REBUTTAL TESTIMONY OF RICHARD KUPREWICZ EVALUATING PG&E'S PIPELINE SAFETY ENHANCEMENT PLAN

CALIFORNIA PUBLIC UTILITIES COMMISSION PIPELINE SAFETY RULEMAKING R. 11-02-019

> February 28, 2012 Revised March 2012

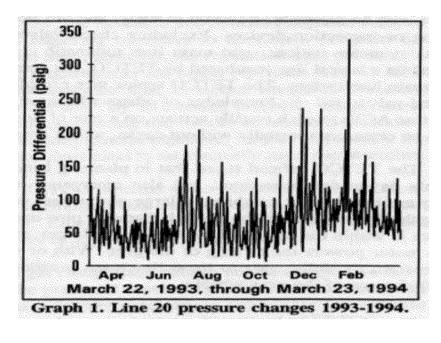
Low-pressure, low % SMYS, hydrotesting can leave very large imperfections in the manufactured pipe seam welds that are much more susceptible to further growth to rupture failure in a relatively short time from pressure cycling than the much smaller imperfections left in high-pressure hydrotesting. This is especially true on many gas transmission pipelines that undergo considerable variations in their operating pressure, which occurs on most gas transmission pipelines. It is a myth that gas transmission pipelines do not pressure cycle. Figure below is an example of a gas transmission pipeline pressure cycle spectrum (MAOP of 975

1 psig) in the public domain whose pipe ruptured from time -delayed damage many years after the
